Re: Surface-water drainage — representations on applications PL_2025_10022 and PL_2026_03223

Site: Land at Witt Road, Winterslow, Wiltshire

PL_2026_03223 — Drainage Flow Path & Downstream Surface-Water Flood Risk

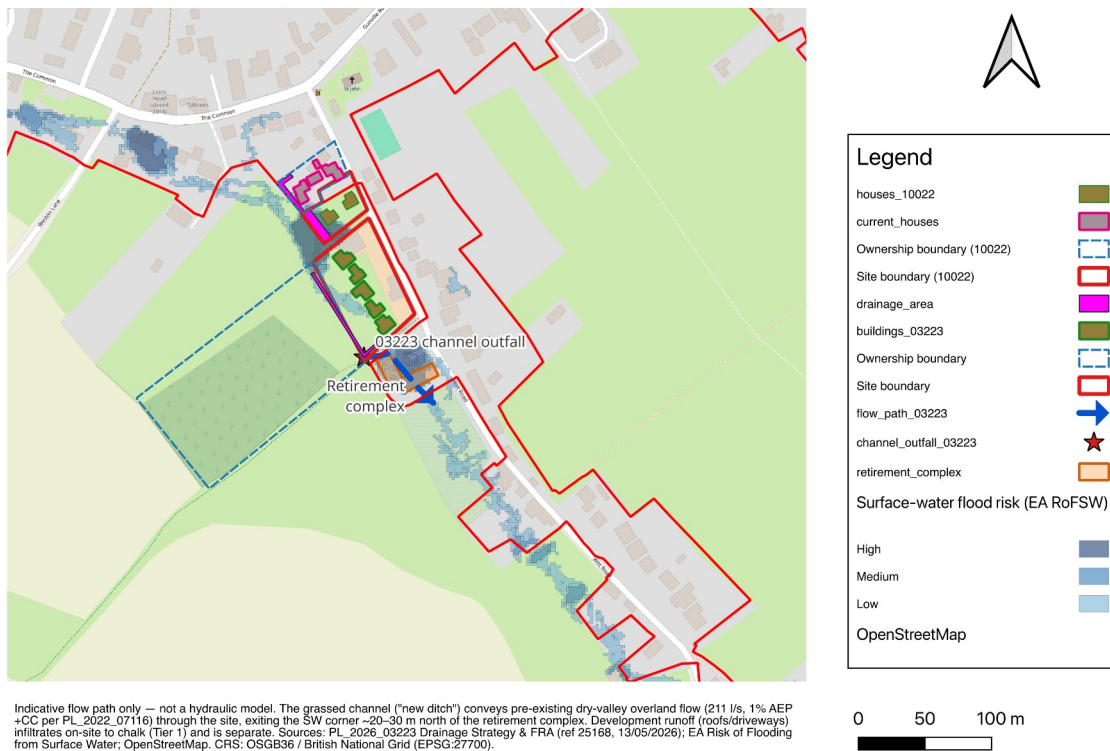
The 03223 channel outfall lies at the south-west corner of that site (approximately NGR 424748, 132440), only some 20–30 m north of the care/retirement complex on Witt Road. The Environment Agency’s Risk of Flooding from Surface Water mapping shows a High-risk band reaching the outfall and the northern edge of that complex.

The applicant’s own Strategy (para 10.1) states only that the channel “mimics the existing run-off regime” — in other words, that it does not increase downstream flow, not that water does not leave the site. Concentrating and routing roughly 211 l/s to a single outfall immediately upstream of an occupied and potentially vulnerable site that is already in a High surface-water flood-risk zone warrants explicit assessment of the receiving ground and of the onward overland route. I do not consider “mimics existing” to be a sufficient answer where the receptor is this sensitive.

1. assess the three related schemes cumulatively, as one hydraulic system, rather than in isolation;
2. require a defined, connected surface-water flow path across the sites, with exceedance flows (beyond the 1% AEP design event) routed and demonstrated to, and beyond, the retirement complex;
3. require verified infiltration testing for each soakaway, and re-validation of the design against the current Environment Agency climate-change allowances;
4. secure long-term ownership, maintenance and adoption responsibility for the conveyance channel/ditch by condition or agreement; and
5. if these matters cannot be satisfied, recommend refusal, or that determination be deferred pending a cumulative drainage assessment.
